**Communication Navigation and Surveillance  
Sub-Group (CNS SG)**

**Fourth Meeting**  
*(Cairo, 25 – 27 September 2011)*

**PROPOSAL FOR AMENDMENT TO ANNEX 10**

**AMENDMENT No. 86**

**Figure B-19. Example data modulation**

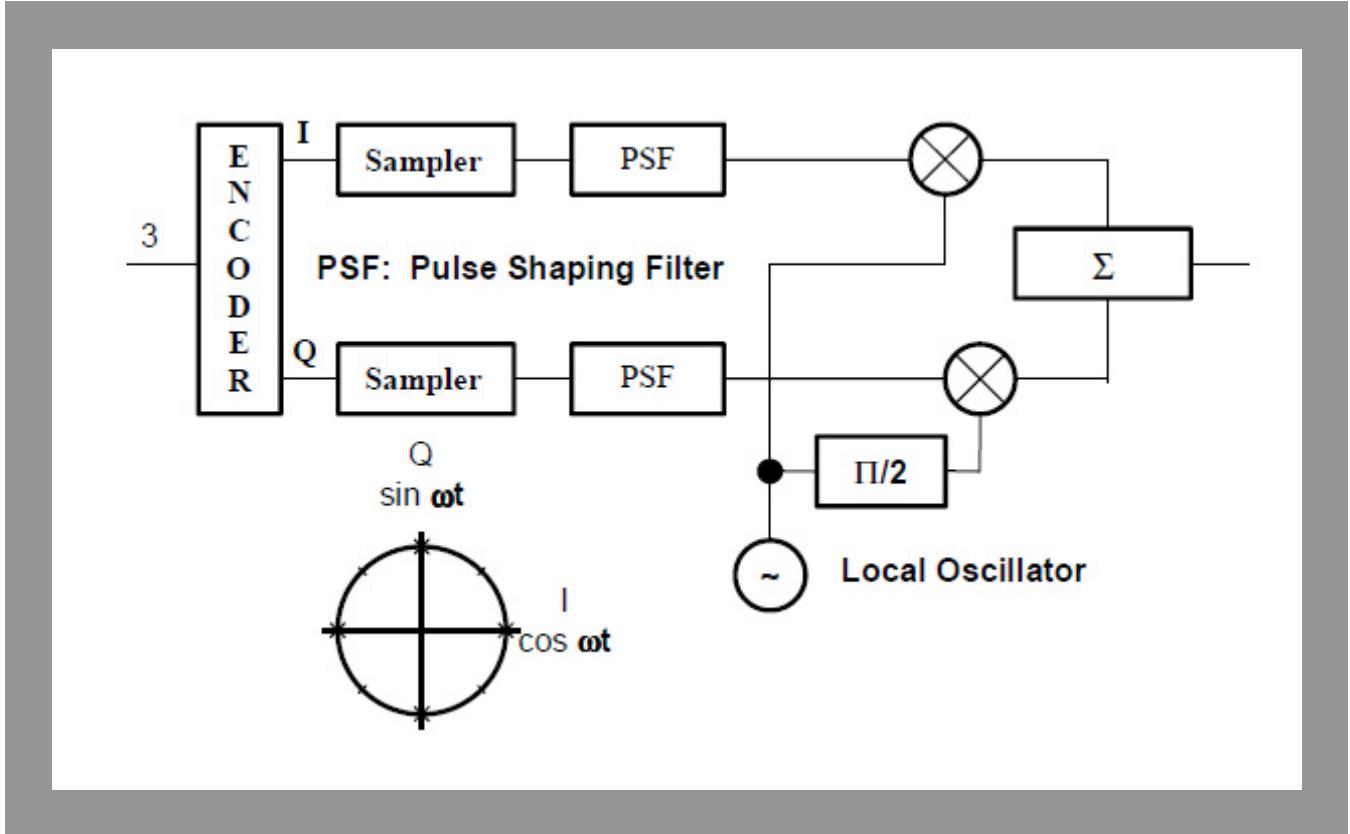
*Note.— The carrier phase for the  $k^{\text{th}}$  symbol ( $\phi_k$ ) is given by:  $\phi_k = \phi_{k-1} + \Delta\phi_k$ . The D8PSK signal may be produced as shown in Figure B-19 by combining two quadrature RF signals which are independently suppressed-carrier amplitude-modulated by base band filtered impulses. A positive increase in  $\Delta\phi_k$  represents a counter clockwise rotation in the complex I-Q plane of Figure B-19.*

Insert, after Figure B-18, the following new figure:
